Waterloo Metro Quarter Over Station Development – Concept Modification 1 and Southern Precinct

State Significant Development Assessment
SSD 9393 MOD 1 and SSD 10437

July 2021

Published by the NSW Department of Planning, Industry and Environment

Figure 22 | Building envelope projections for social housing building (Source: Applicant's Concept Modification)

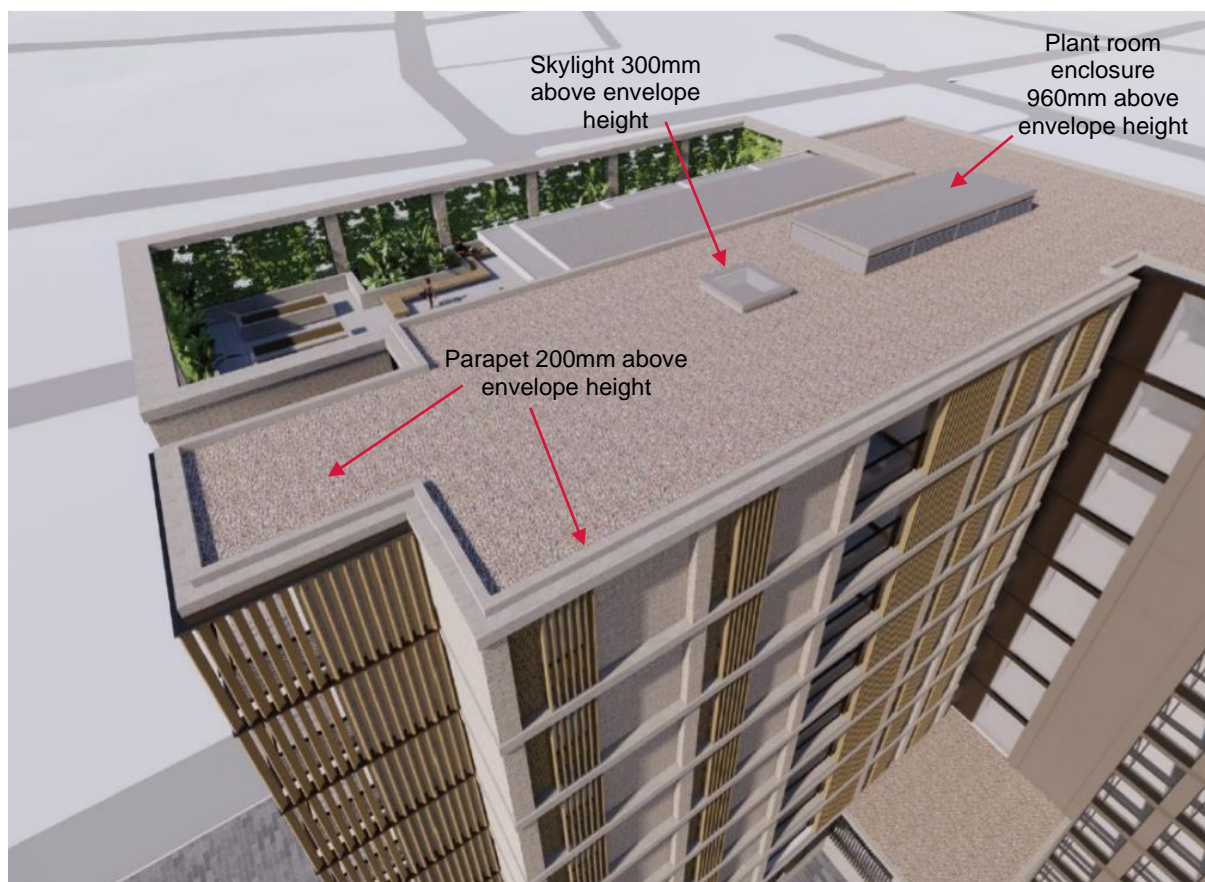
With regard to the mid-rise social housing building, the Department notes it has a maximum height of RL 64.06, which is equal to the Concept Approval maximum height. However, the modification seeks approval for three minor height projections relating to a raised parapet, a skylight and a plant room enclosure on the roof level in the detailed design which are 200mm, 300mm and 960mm above the approved envelope respectively (**Figure 22**).

The Department has carefully considered the proposal against the Concept approval and the issues raised in submissions. Overall, the Department is satisfied the proposed building heights are appropriate because:

- the overall building is 33m lower than the maximum LEP height control;
 - the proposed skylight and plant enclosure are located away from the street boundaries and are not visible from street level;

Figure 23 | Section showing building separation between student housing tower and social housing building (Base source: Applicant's EIS)

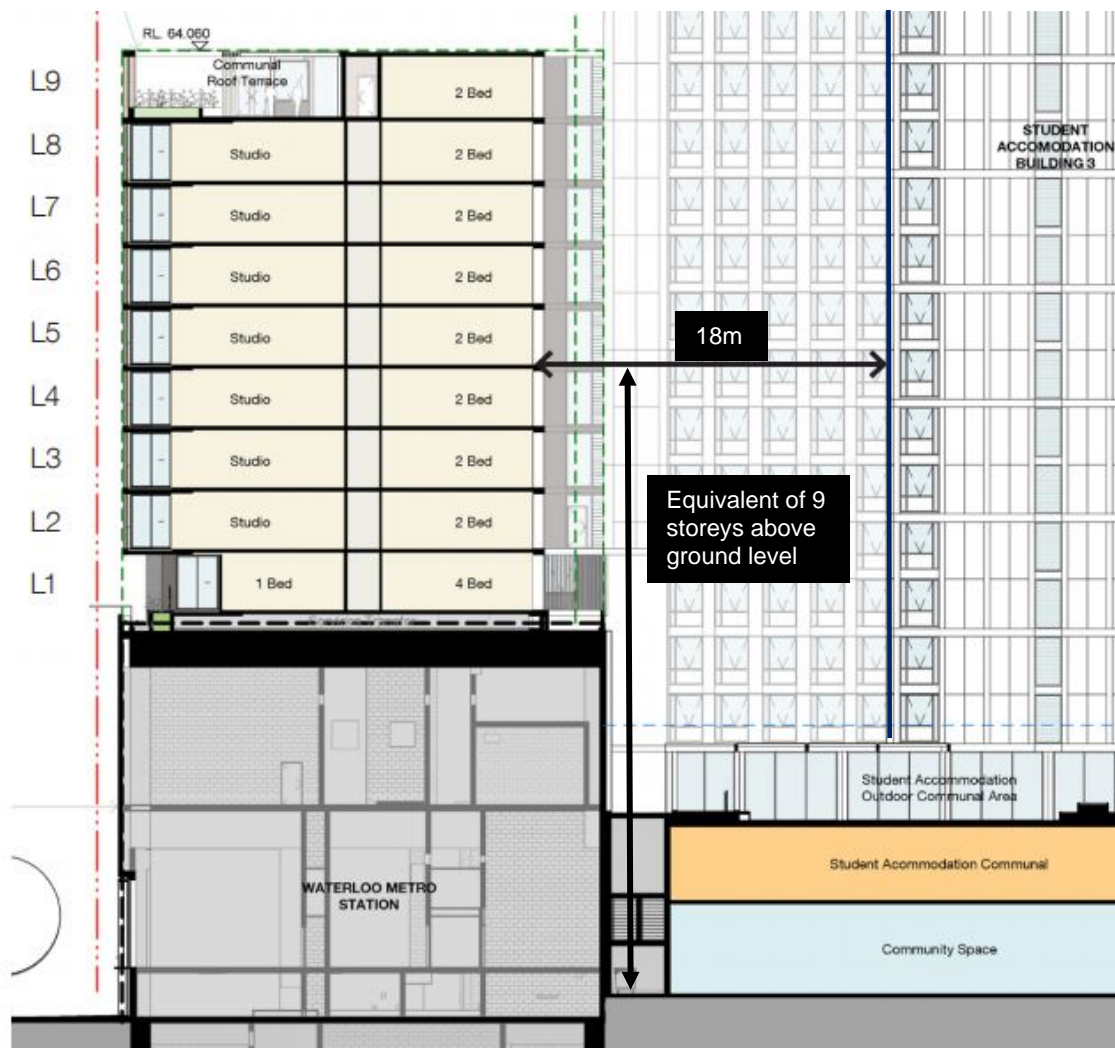
The building separation between the proposed social housing building and the student housing tower is 18m which is 6 m less than the 24 m separation distance recommended in the ADG. The Department considers the required 24m separation distance applies from Levels 5 to 9 (5 floors) of the proposed social housing tower given it sits on top of the future Metro Station which has an equivalent height of five storeys (**Figure 23**).

The reduced separation distance affects two apartments per floor (10 of out 70 apartments) within the eastern elevation of the social housing building and 20 apartments within the western elevation of the student housing building.

Council raised concerns about potential visual privacy impacts between the buildings. Council recommended the proposed privacy screens to the student housing building be replaced by an alternative such as bay windows with angled glazing toward the north and a solid material to the east to give student housing occupants views away from the social housing building.

Figure 28 | Overshadowing analysis on Alexandria Park showing impact caused from Central and Southern Precinct buildings at 9:30am in midwinter (Source: Applicant's EIS)

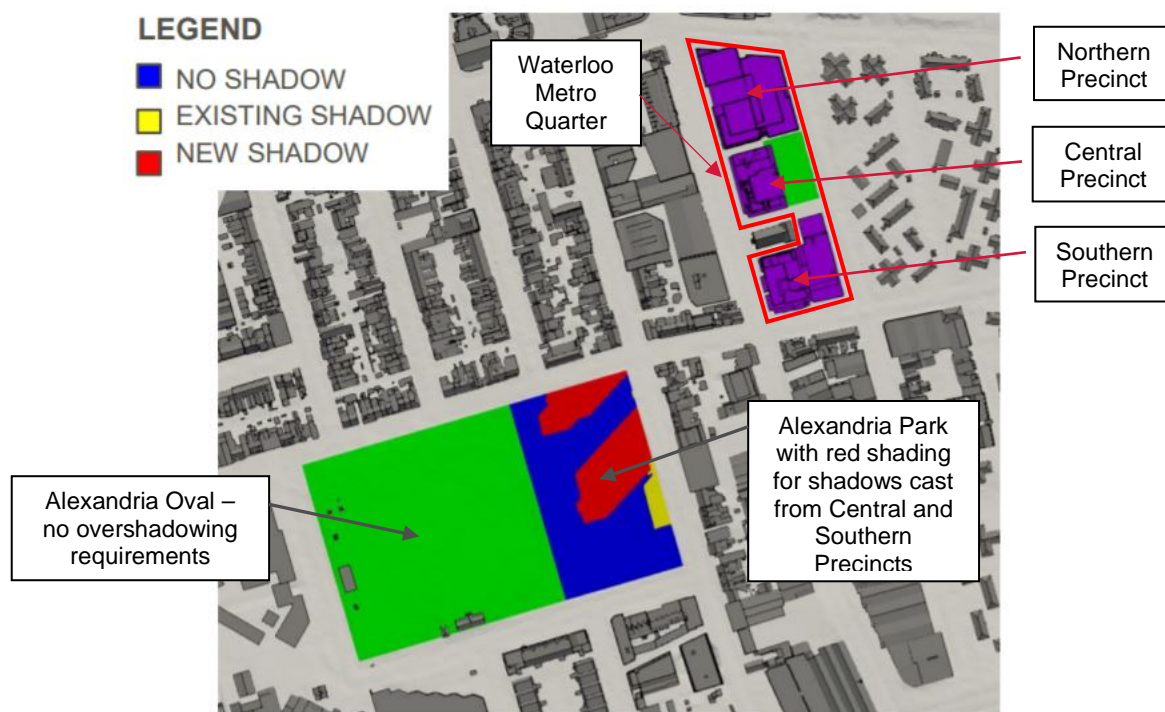
Public submissions raised concerns with overshadowing impacts to Alexandria Park.

The proposal is supported by solar analysis which identifies the potential overshadowing impacts of the proposed buildings to Alexandria Park. The submitted shadow diagrams identified the overshadowing impacts from the Waterloo Metro Quarter are cast by the proposed buildings in the Central and Southern Precincts (**Figure 28**).

The Department engaged an independent solar access consultant to review the Applicant's shadow analysis. The Department's consultant accepted that the Applicant's analysis is accurate and advised the modelling provided sufficient detail to assess the proposal.

Figure 29 | Solar access to Alexandria Park Heritage Conservation Area to the west at 10am
(Source: Applicant's EIS)

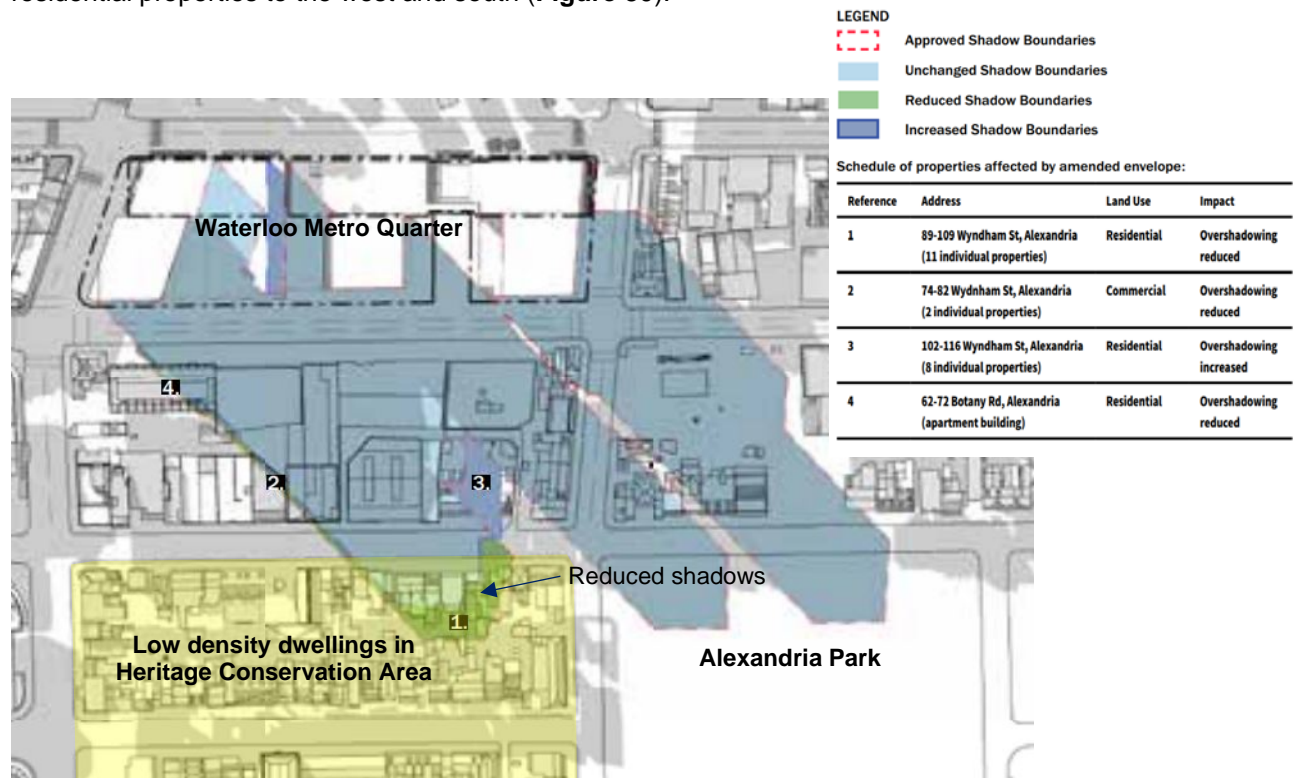
Council acknowledged the improvement to solar access to residential properties in the Heritage Conservation Area due to the reduced height of the Amending Concept SSD and Northern Precinct Detailed Design compared to the Concept Approval (**Figure 29**).

However, Council advised that the Applicant's solar analysis did not demonstrate specific criteria in the Design Guidelines had been met with respect to analysis of all living rooms windows and did not adequately consider impacts to residential properties to the south.

Figure 31 | Typical west elevation of student accommodation façade showing windows outlined in red and amount of window in shade on 4 February “Summernox” (Source: Applicant’s RtS)

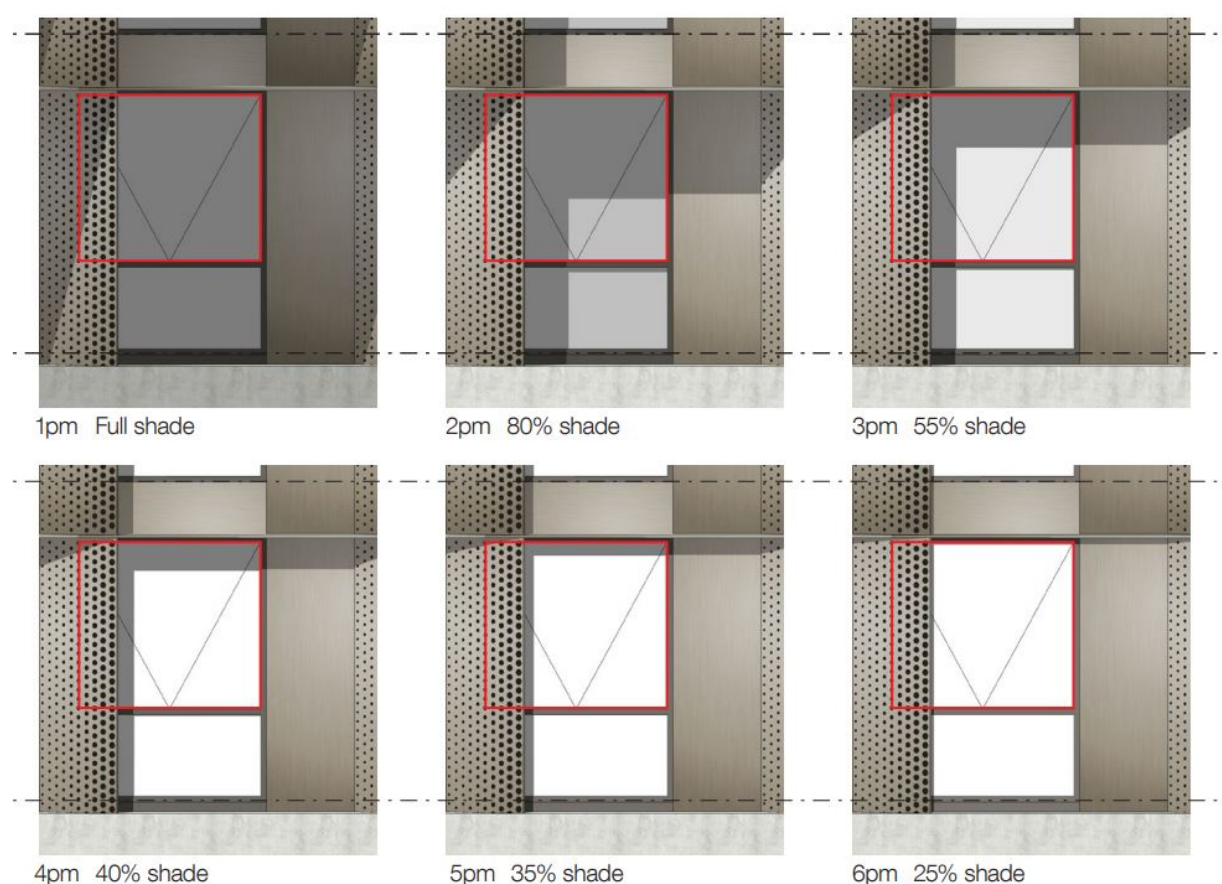
The northern and western elevations of the student housing building are exposed to direct summer sun and associated heat load. To mitigate this the proposal includes awnings on the north and western facades and tinted high-performance glazing to the north and west.

Council recommended externally mounted, individually operated shade devices allowing occupants to control heat load. Council also recommended external sunshade devices be provided to the eastern elevation of the social housing building similar to the west elevation of the student housing tower.

In response to Council’s submission, the Applicant provided a Façade Shading Analysis Report and increased the depth of the awnings on the northern elevation of the student housing building to match the depth of those on the west elevation. The Applicant contended that when compared to no shading devices being used, the revised proposal would achieve a 45% heat load reduction (**Figure 31**), and further mitigation is unnecessary.

Figure 35 | Proposed ground floor showing extent of active street frontage (Source: RtS)

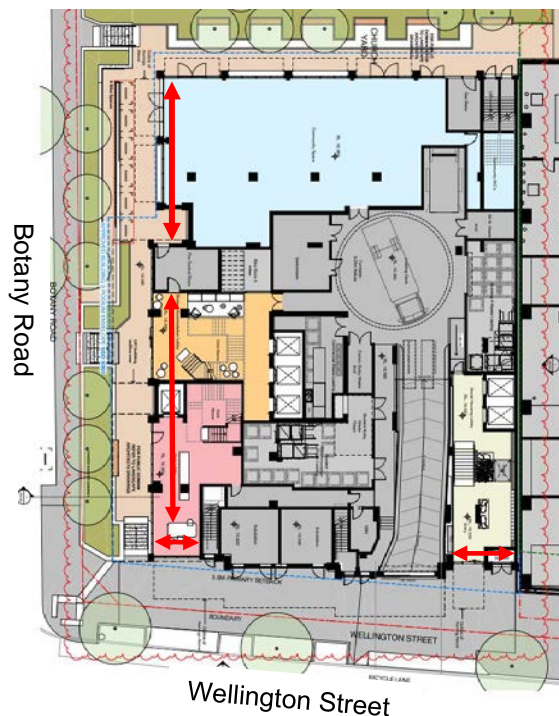
Council noted the proposal does not comply with Clause 7.27 of the Sydney LEP 2012 as active street frontages are not provided for the full extent shown on the LEP map (**Figure 36**) and a statement under Clause 4.6 of the LEP in relation to the non-compliance would be required.

In response, the Applicant lodged a request under Clause 4.6 of the Sydney LEP in relation to building services along the frontages that are not excluded by Clause 7.27. The request addresses one fire control room along Botany Road and two substations along the Wellington Street frontage (**Figure 36**).
